**SAN ANTONIO WATER SYSTEM
MILDRED 24" SEWER OUTFALL – DR881 PROJECT**

**SAWS JOB NUMBER 15-4521
SOLICITATION NO. CO-00165-FF**

**ADDENDUM NO. 1
MARCH 30, 2018**

REVISED SHEET 3 OF 14

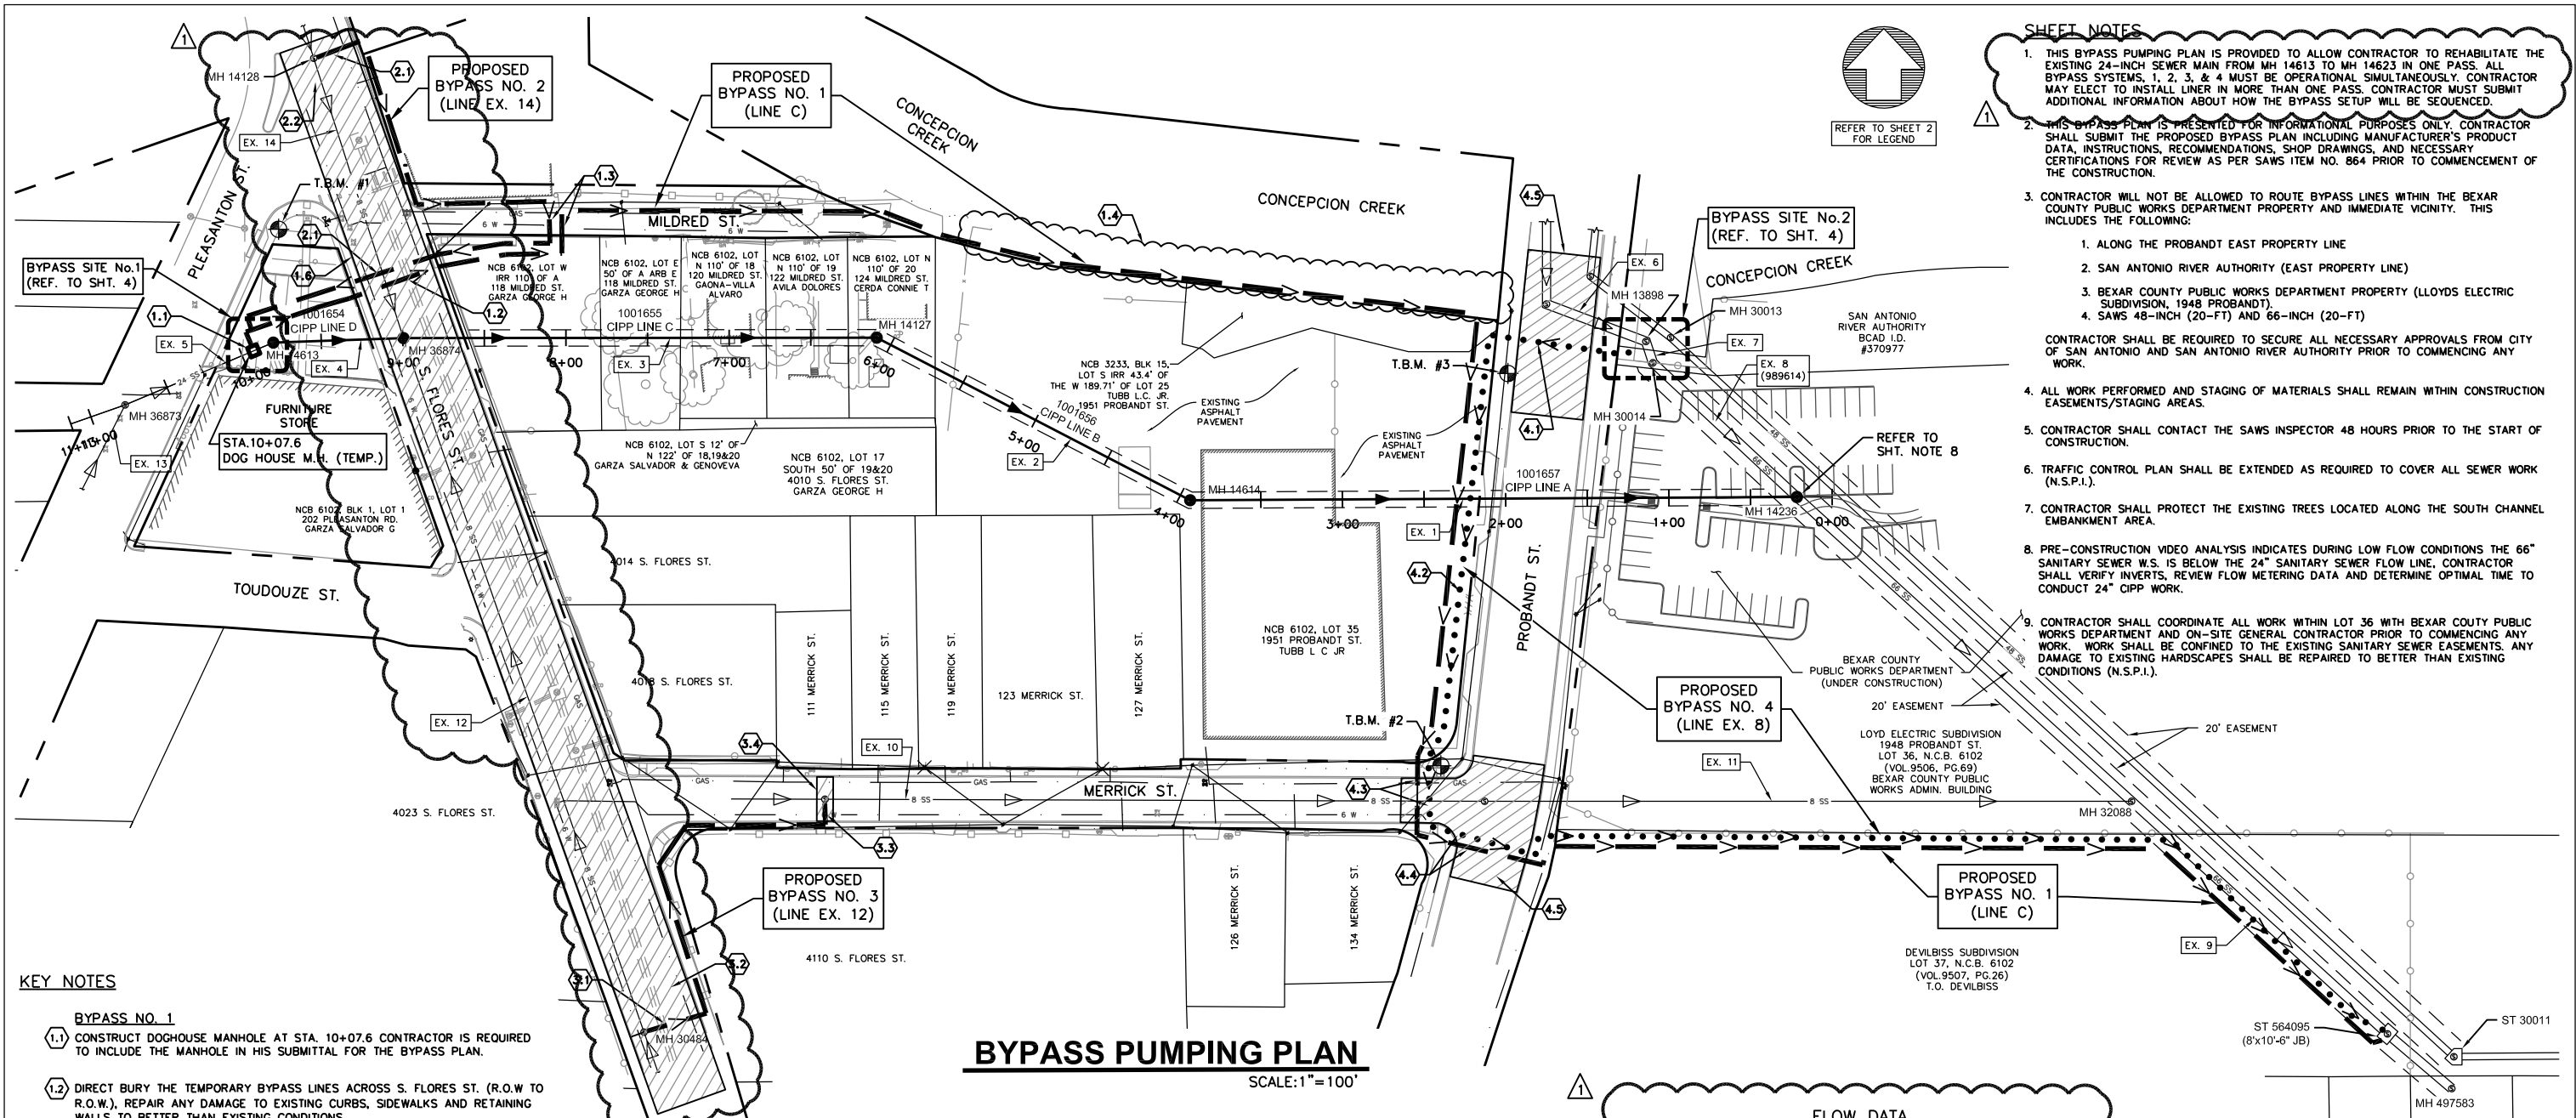
1. Please confirm that COSA ROW agrees to the patching of asphalt as shown on the plans given the newly pave conditions in the project area.
Response: *Refer to Sheet 3 Key Notes stating pavement limits shall include full mill and overlay for the asphalt repairs. Per project specifications for the Bypass Plan, pavement restoration shall be incidental for the bypass piping installation.*

2. Is the by-pass suction manhole shown at STA. 10+07.6 a temporary or permanent structure? – If temporary, please indicate specification No.
Response: *The bypass suction manhole aforementioned can be installed as a permanent structure as shown on sheet 3 and shall be installed to SAWS Specification 850. There will be no separate pay item for this structure and it should be considered subsidiary to the bypass pumping operation per SAWS Spec 864-S2.*

Response: *Refer to Sheet 3 - A table of Flow data has been added.*

7. Please confirm Sheet Note #1 on Sheet 3 regarding means and methods.
Response: Refer to Sheet 3 Key Notes stating that in the event the Contractor shall request to install liner in more than one pass, additional information shall be presented by Contractor to the Engineer prior to commencing work and study how the bypass setup will be sequenced.

9. On sheet 3 of 14 on the by-pass layout it shows a Dog House MH (Temp) at STA10+07.6. Please confirm that this is a temporary manhole, or will it be a permanent manhole per SAWS specifications? If it is to be a permanent manhole will this be paid by SAWS?
Response: Refer to response #2 of this Addendum #1.

Sheet 3 of 14 - Revised Notes to Drawing:

- Added the following to Note 1 of Sheet Notes: *CONTRACTOR MAY ELECT TO INSTALL LINER IN MORE THAN ONE PASS. CONTRACTOR MUST SUBMIT ADDITIONAL INFORMATION ABOUT HOW THE BYPASS SETUP WILL BE SEQUENCED.*

- Added the Discharge Flow Table.

- Revised the pavement limits required on S Flores as part of the bypass pumping plan.

- THIS BYPASS PUMPING PLAN IS PROVIDED TO ALLOW CONTRACTOR TO REHABILITATE THE EXISTING 24-INCH SEWER MAIN FROM MH 14613 TO MH 14236 IN ONE PASS. ALL BYPASS SYSTEMS 1, 2, 3, & 4 MUST BE OPERATIONAL SIMULTANEOUSLY. CONTRACTOR MAY ELECT TO INSTALL LINER IN MORE THAN ONE PASS. CONTRACTOR MUST SUBMIT ADDITIONAL INFORMATION ABOUT HOW THE BYPASS SETUP WILL BE SEQUENCED.

- BYPASS NO. 1**
- CONSTRUCT DOGHOUSE MANHOLE AT STA. 10+07.6 CONTRACTOR IS REQUIRED TO INCLUDE THE MANHOLE IN HIS SUBMITTAL FOR THE BYPASS PLAN.
 - DIRECT BURY THE TEMPORARY BYPASS LINES ACROSS S. FLORES ST. (R.O.W TO R.O.W.), REPAIR ANY DAMAGE TO EXISTING CURBS, SIDEWALKS AND RETAINING WALLS TO BETTER THAN EXISTING CONDITIONS.

- MILL AND OVERLAY S. FLORES ST. FROM 5-FT NORTH OF BYPASS 2 TO 50-FT SOUTH OF BYPASS 3. RE-STRIPE 690-LF~4" VEHICULAR (WHITE) LANES (2) WITH BUTTONS AND 690-LF~DOUBLE (YELLOW) CENTERLINE WITH BUTTONS.

- MILL AND OVERLAY 50-FT. OF PROBANDT STREET PAVEMENT EACH SIDE OF BYPASS TRENCH (CURB TO CURB). RE-STRIPE 400-LF~4" VEHICULAR (WHITE) LANES (2) AND 200 LF ~ DOUBLE (YELLOW) CENTERLINE WITH BUTTONS.

Comkey	UnitID	ADF (MGD)	PDF (MGD)	PWF (MGD)	Pipe Size (in)	Basin
1001654	14613.1	0.99	1.43	6.48	24	Central
1001655	36874.1	1.02	1.48	6.68	24	Central
1001656	14127.1	1.02	1.48	6.68	24	Central
1001657	14614.1	1.02	1.48	6.70	24	Central
989614	30014.1	5.05	8.46	41.29	60	Central
992529	14236.1	6.07	9.73	44.45	66	Central
